STATE OF HAWAII
DEPARTMENT OF TRANSPORTATION
HIGHWAYS DIVISION

ADDENDUM NO. 3

MAUNA KEA MAINTENANCE BASEYARD

STATE PROJECT NO. 200A-01-10

Figure R301.2 (9a) County of Hawaii Effective Basic Wind Speed, V_{eff} , for Components and Cladding for Buildings less than 100 ft. Tall

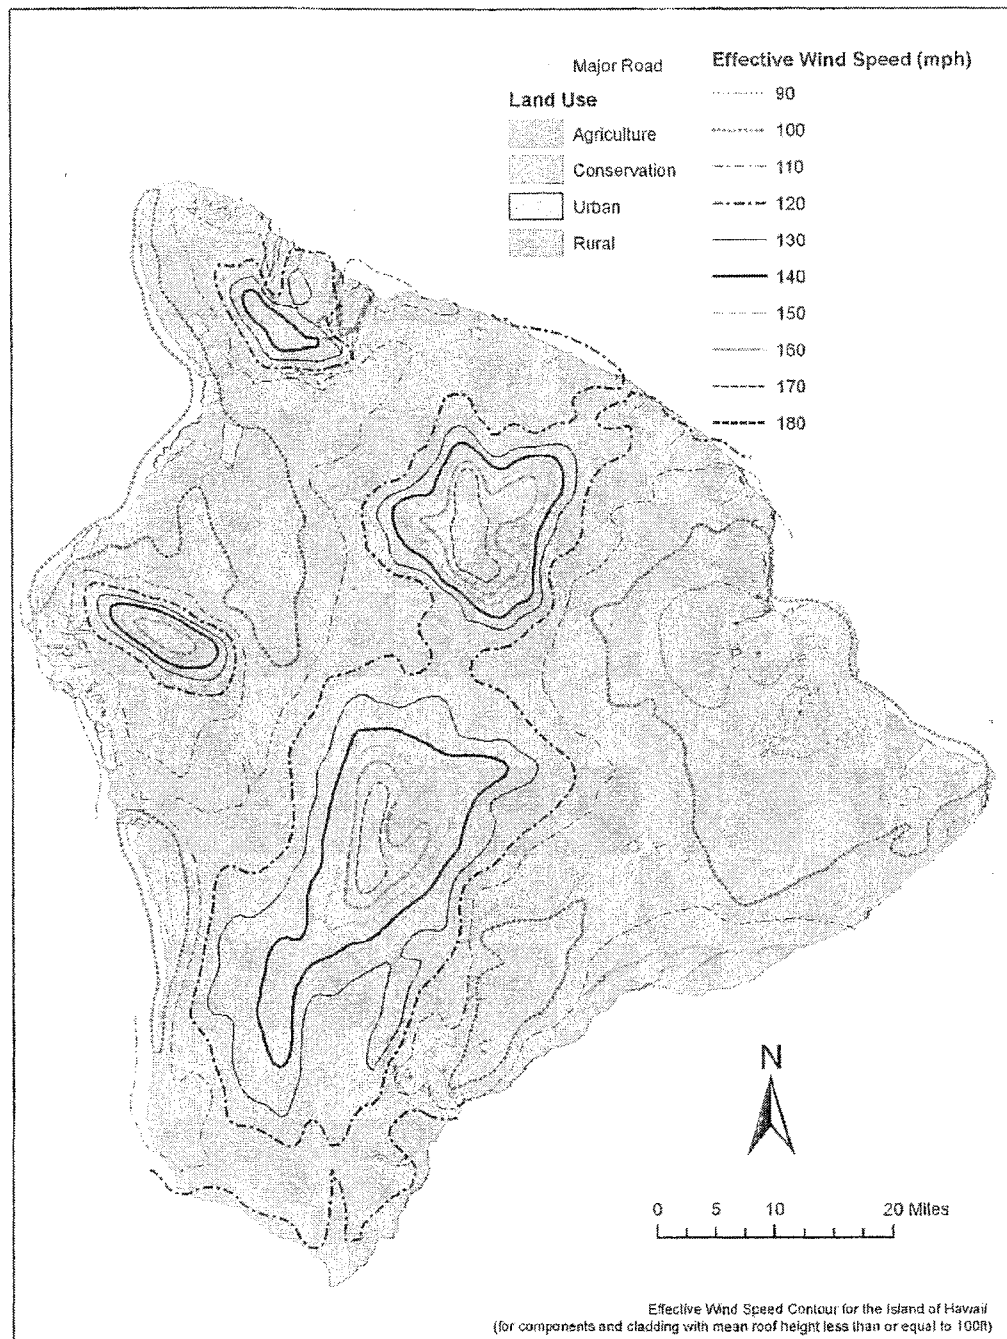
4. QUESTION: General Notes on plan sheet S0.1 Wind Loads indicates a
Basic Wind Speed of 120 MPH and a Topographic Factor (Kzt) of 1.55.
County of Hawaii is 2006 IBC, and Basic Wind Speed of 105 MPH.
Estimated velocity pressure with wind at 120 mph and Kzt of 1.55 is in
excess of 44 PSF. Please confirm wind speed of 105 mph and Kzt of 1.55,
is acceptable.

*REPLY: Use 120 MPH and Kzt 1.55 per Hawaii Wind Design Amendments
to the International code 2006 Edition. (See attached excerpts from Guide
to the Wind Design Provisions of the Hawaii State Building Code.)*
